ADDENDUM

Date Issued:	Jul 2, 2024
Project:	Intermountain Health McKay Dee Hospital – Mammography Scan Room Addition 4401 Harrison Blvd Ogden, UT 84403
Addendum Number:	1

Electrical Addendum #1

Demolition
Floor Plan
Level 4

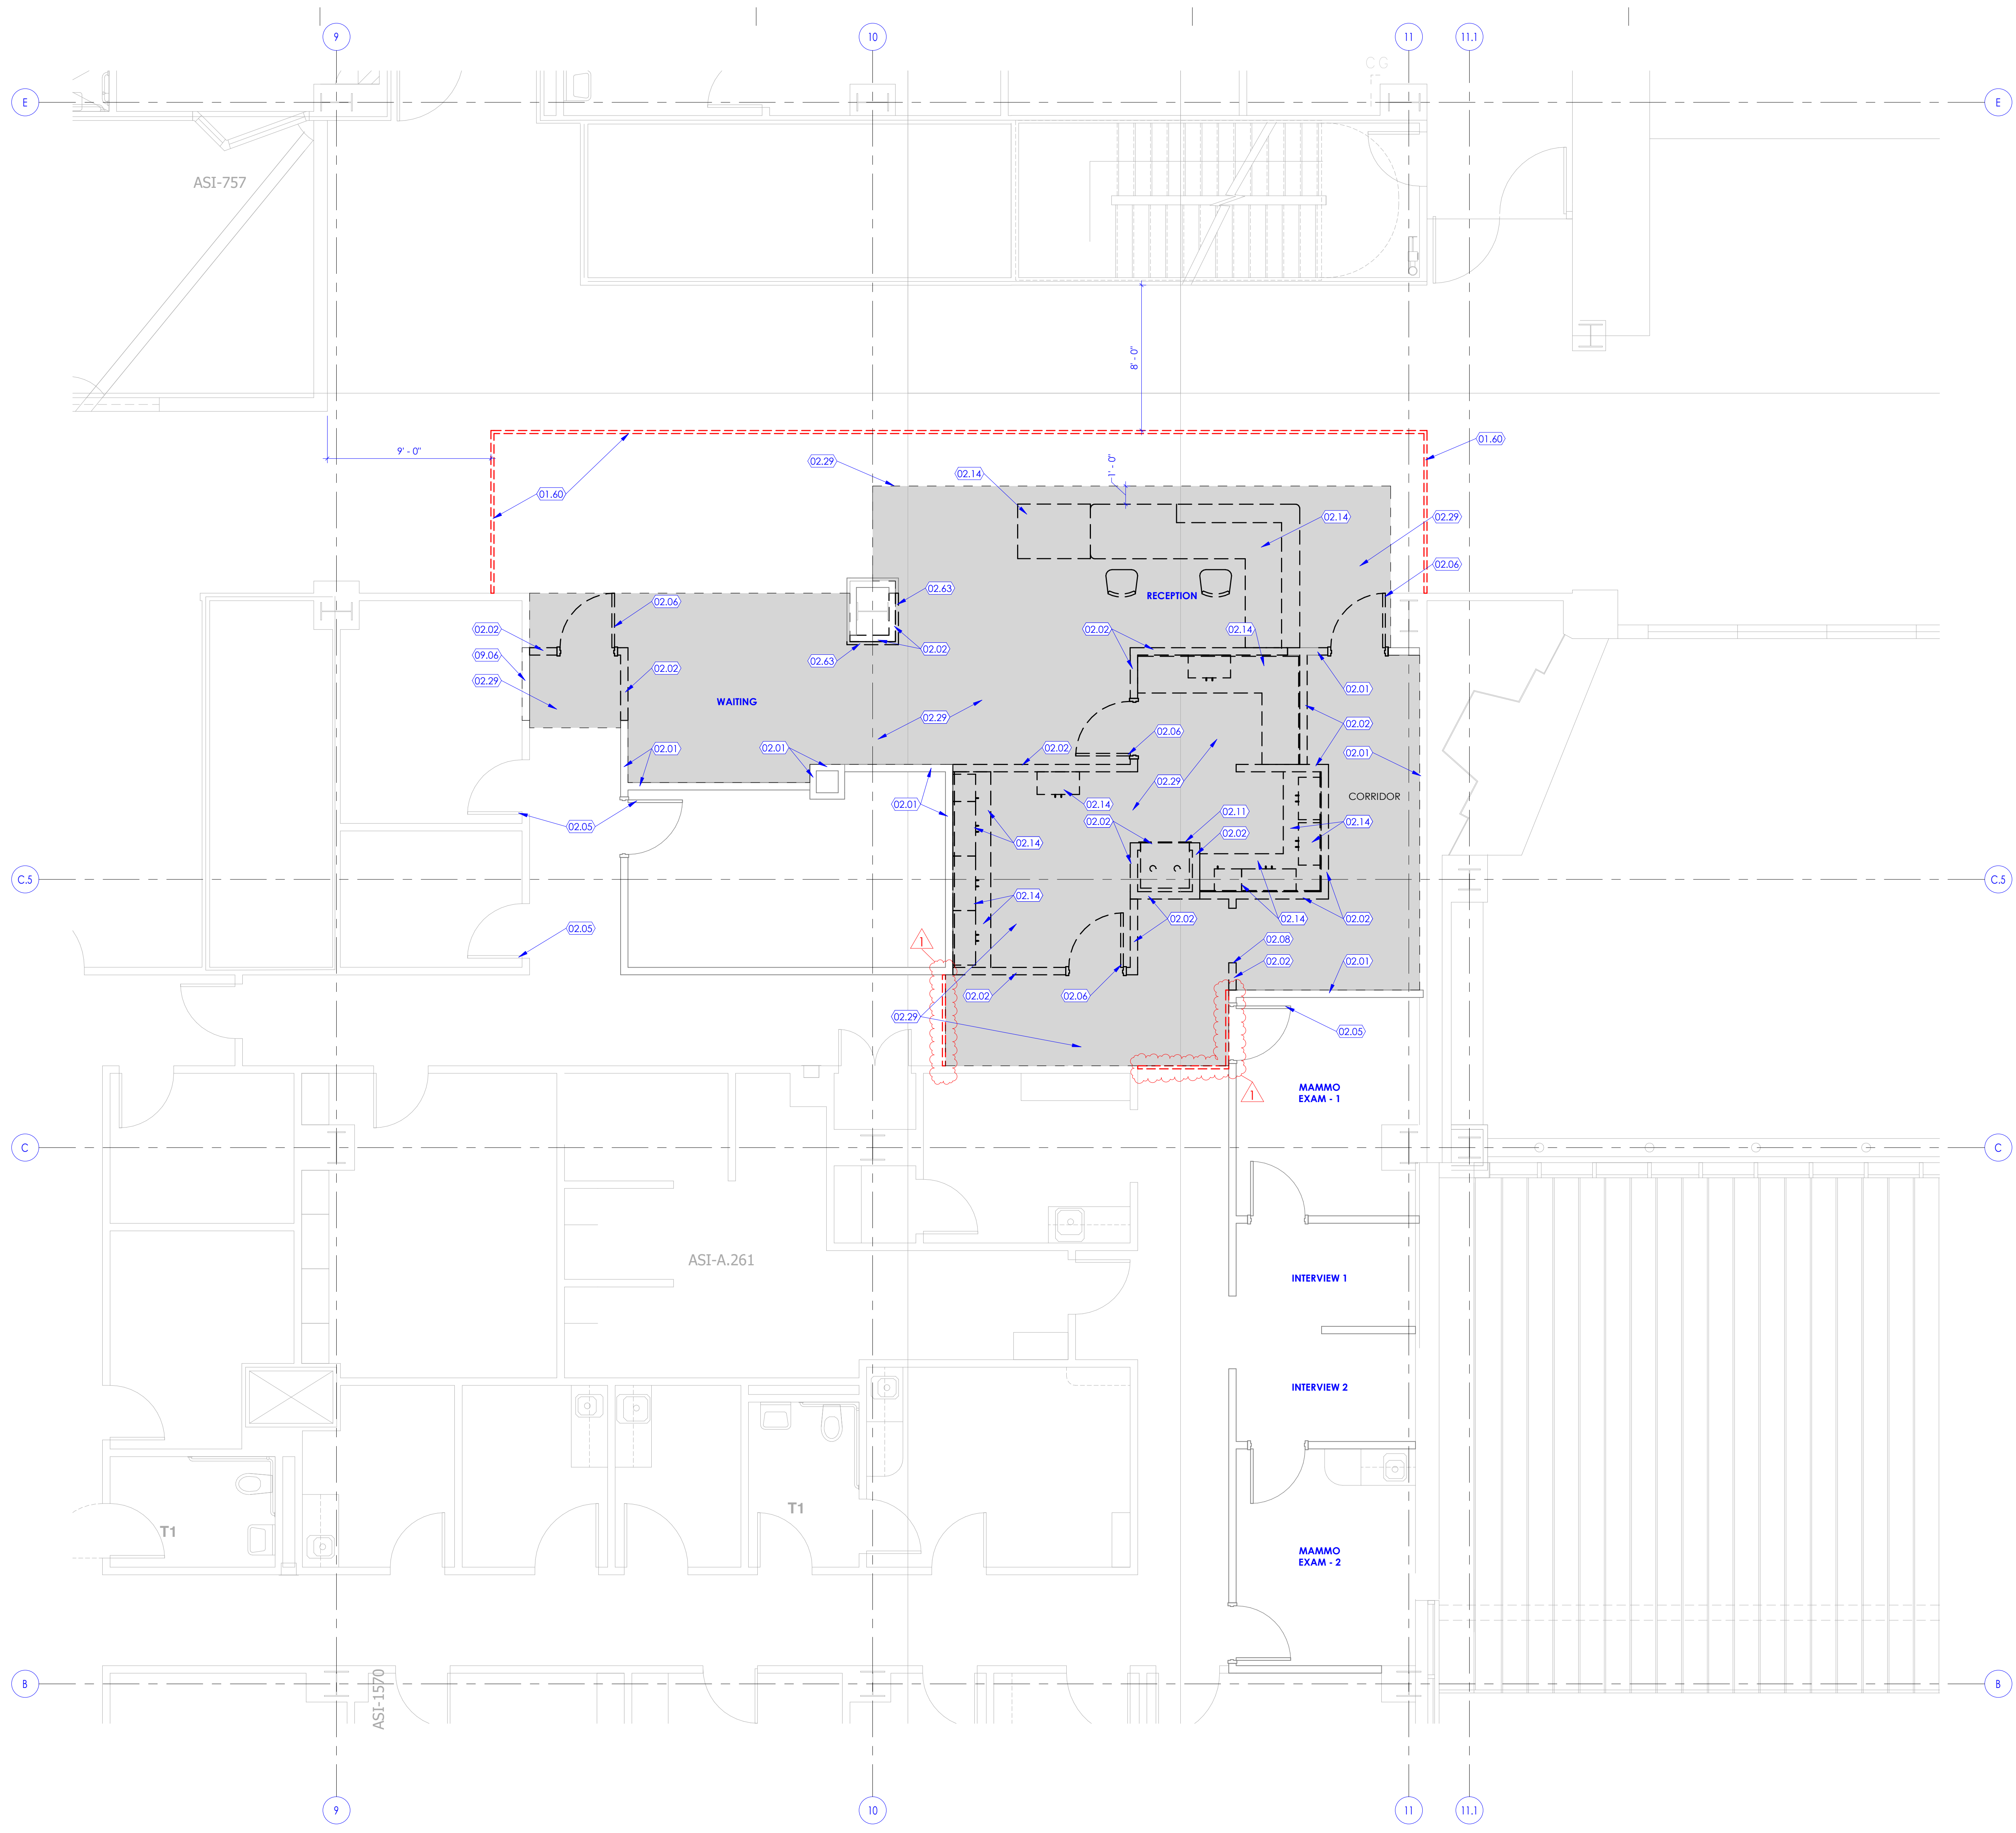
Item Number	General Items Description
	<p>Questions from Bidders:</p> <p>Question #1: Adding additional ICRA not indicated on the drawing set was talked about on the walk. Please indicate where this is needed to complete a full containment. Response: See Demolition floor plan Sheet A111</p> <p>Question #2: ED101 Sheet Note 7 states "REMOVE ALL ABANDONED RACEWAY, CONDUIT, WIRING AND CABLING WHETHER ABANDONED PREVIOUS TO THIS PROJECT OR AS A RESULT OF THIS PROJECT. NOT ALL ABANDONED ITEMS ARE SHOWN ON THESE PLANS AND FIELD VERIFICATION OF DEMOLITION SCOPE EXTENT IS REQUIRED. Because this is unquantifiable, is an allowance for this portion of the work acceptable? Response: Yes, please include an allowance of \$5,000 in your proposals for this work.</p> <p>Question #3: The Demo sheets call for the Ceiling grid to remain and tile to be removed and replaced. But in the finish schedule it calls for new tile and matching grid. Please confirm there is to be new grid and tile throughout. Response: Yes, please provide new grids and new 2' x 2' ceiling tiles throughout. Ceiling tiles in the Reception A110, Mammo Exam #3 A111, Interview A112, Work A113, and Corridor A114 to be ACT Type 1 – Armstrong Ultima Health Zone 1935. Ceiling tiles in the Waiting/Lobby, Corridor A116, and Corridor A147 to match adjacent existing. For bidding purpose please bid these as ACT Type 1 but will need to be field verified to match adjacent existing. See updated finish plan Sheet A117</p> <p>Question #4: What is the floor to deck height on Level 4? Response: 15'-0".</p> <p>Question #5: The bid form in the specifications is different than the one provided in the document log. Are we to replace the one from the document log with the one from the specifications? Response: No. Please use the one provided in the document log.</p>

Sheet Number	Drawings
Architectural Drawings	
A111	Added new ICRA walls.
A116	Provided clarification on new ceiling tiles an grids. Also see answer o Question #3 above.
Electrical Drawings	
	See attached electrical addendum #01

- 01.60 DASHED LINE INDICATES FLOOR TO CEILING DUST PROOF CONSTRUCTION BARRIER TO PREVENT DUST AND DIRT MIGRATION AND TO SEPARATE AREAS OCCUPIED BY THE OWNER FROM FUMES AND NOISE. CONSTRUCTION BARRIER TO BE ERRECTED WITH 3 5/8" 20 GA. MTL STUDS @ 16" O.C. FRAMING WITH 5/8" TYPE 'X' GYPSUM BOARD ON BOTH SIDES. TAPE & SEAL ALL JOINTS AND OPENINGS. SEAL JOINTS AT PERIMETER. PAINT WALL ON EXISTING CORRIDOR SIDE. PARTITION TO BE EQUIPPED WITH 4'-0" LOCKABLE MAN DOOR WITH STICKY MATS ON BOTH SIDES OF DOOR. COORDINATE WITH OWNER FOR EXACT LOCATION OF CONSTRUCTION BARRIER. PRE-FABRICATED RIGID ICRA BARRIERS ARE ALSO ACCEPTABLE. OTHER ICRA PERMITS MAY BE REQUIRED. COORDINATE WITH FACILITIES AND INFECTION PREVENTION.

**LEVEL 4
AUXILIARY
PLAN**

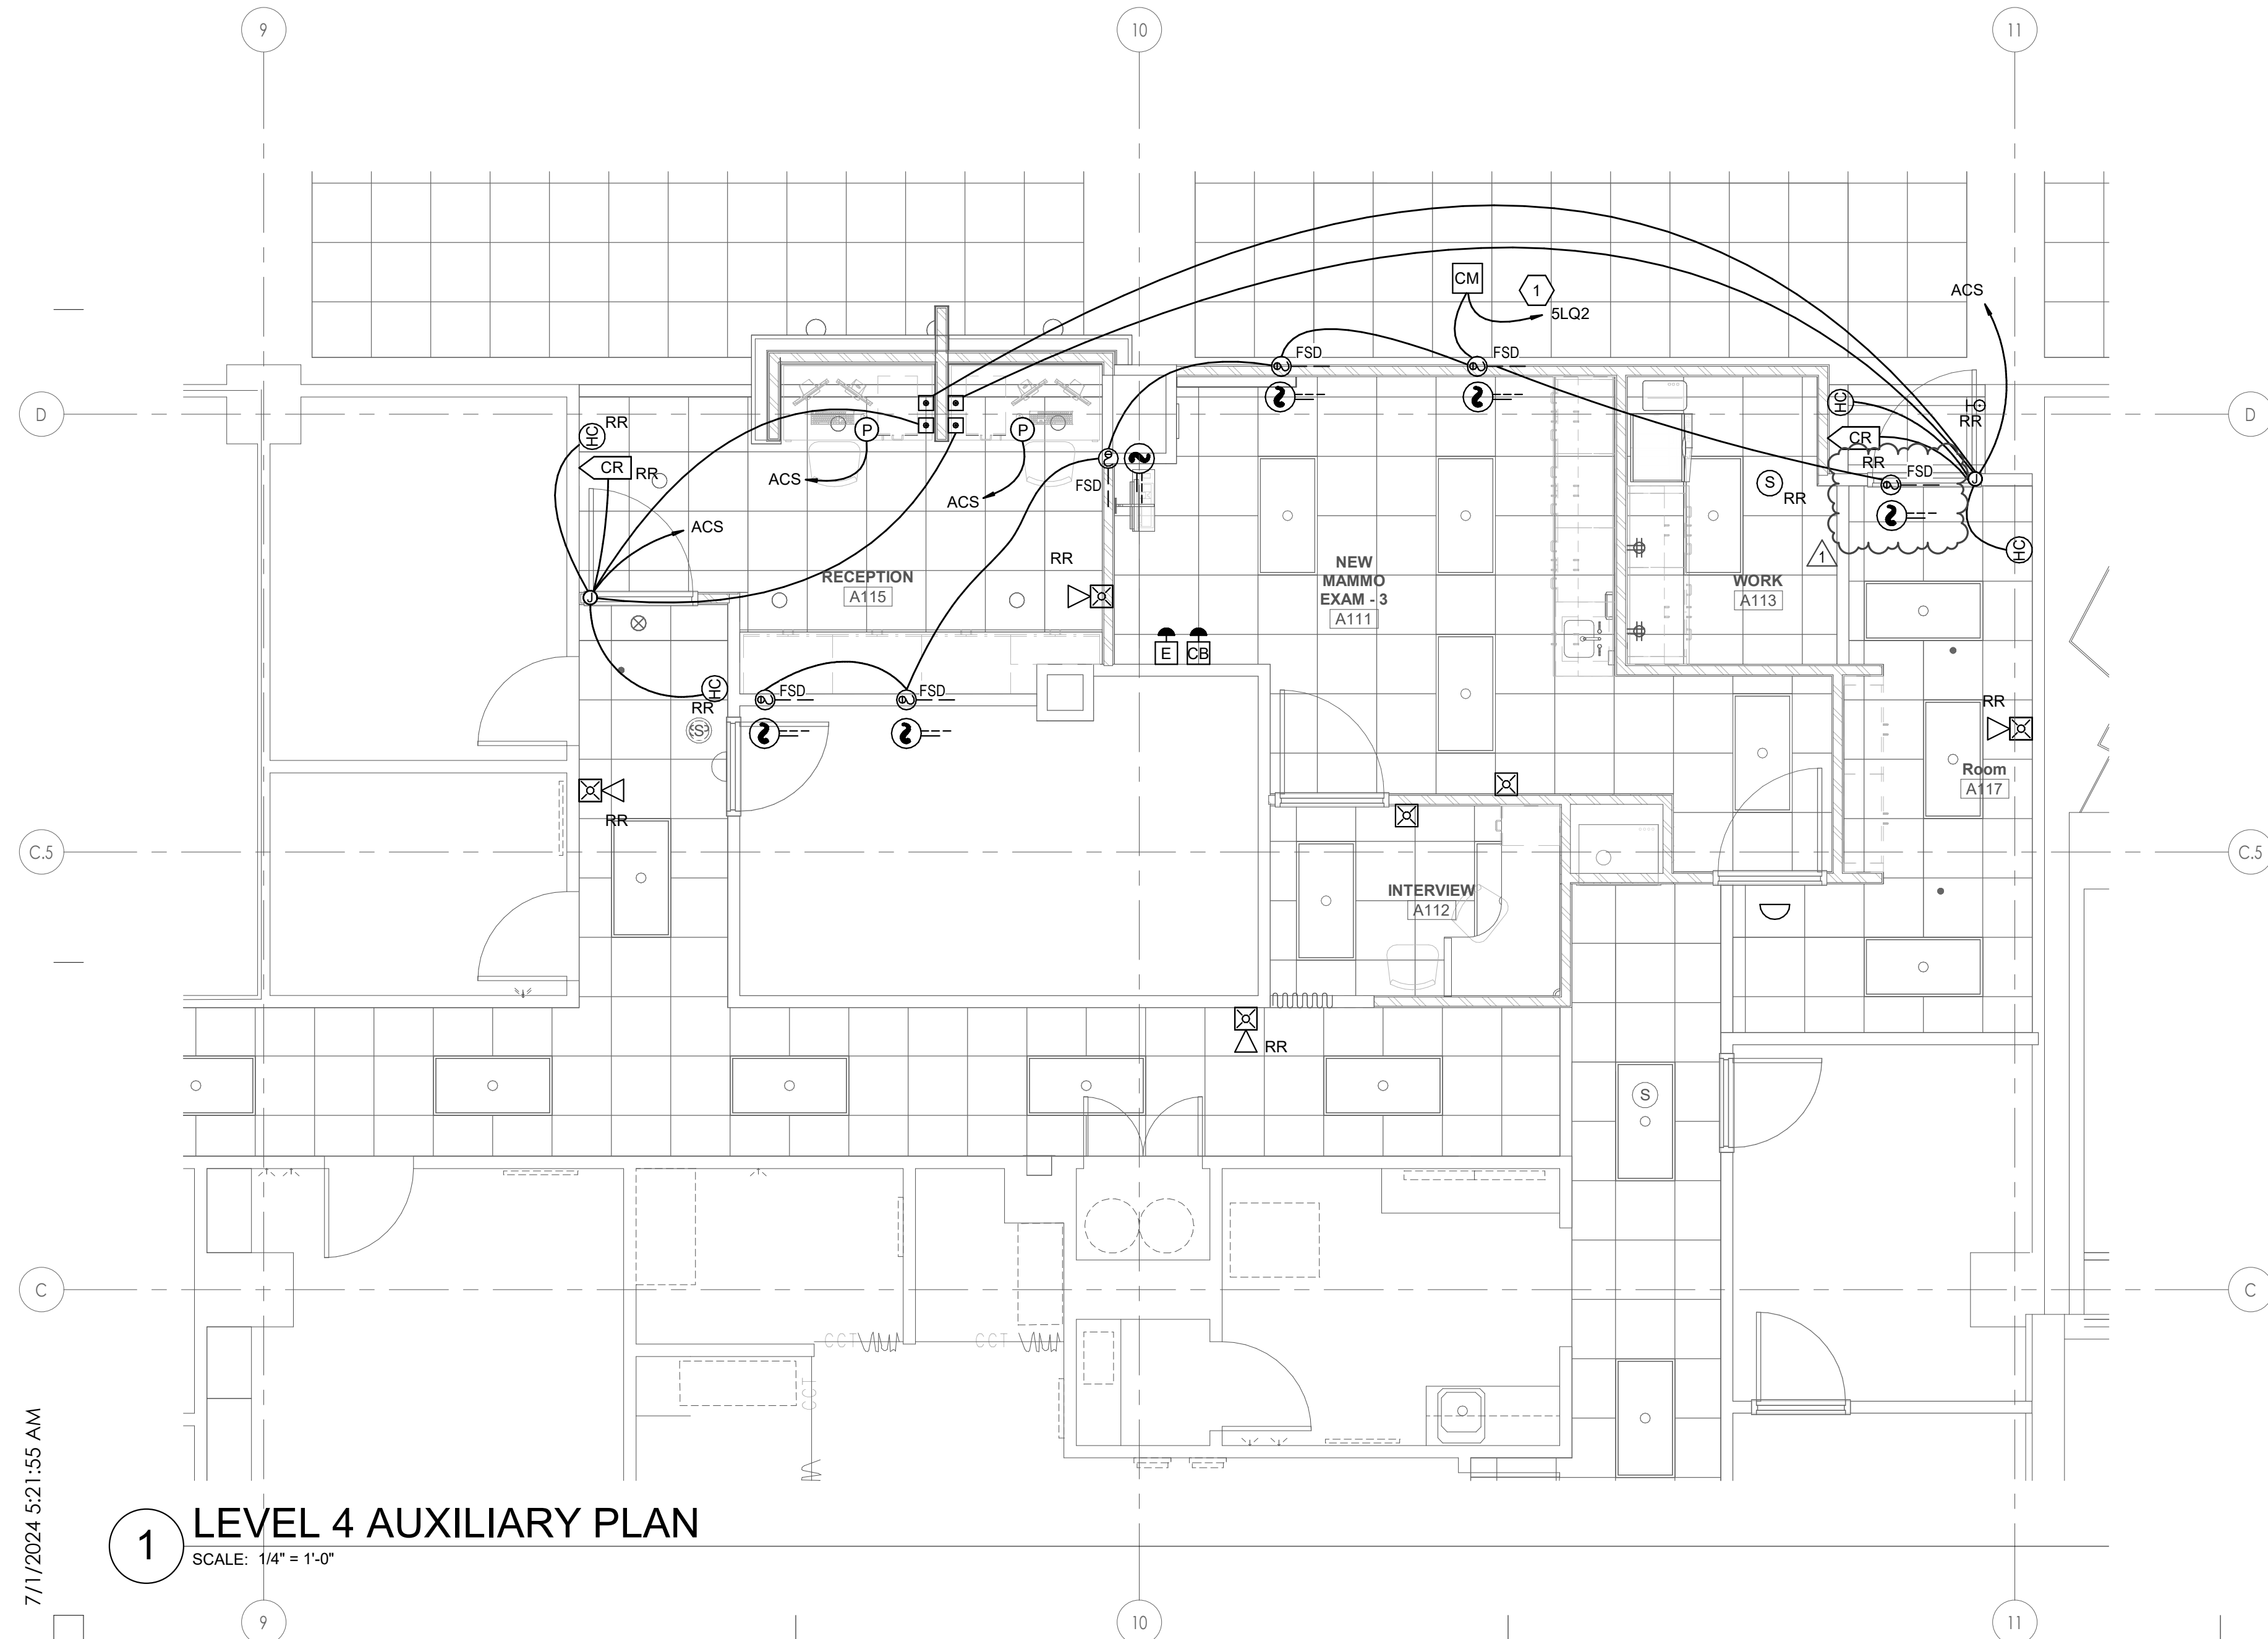
1. The electrical sheet is missing a fire damper.
 - a. This has been added to the electrical sheet.

2. EY01: Level 4 Auxiliary Plan
 - a. Added power for missing fire smoke damper.

1 PROVIDE NEW 20A/1P CIRCUIT FROM EQUIPMENT BRANCH PANEL LOCATED IN MECHANICAL PENTHOUSE.
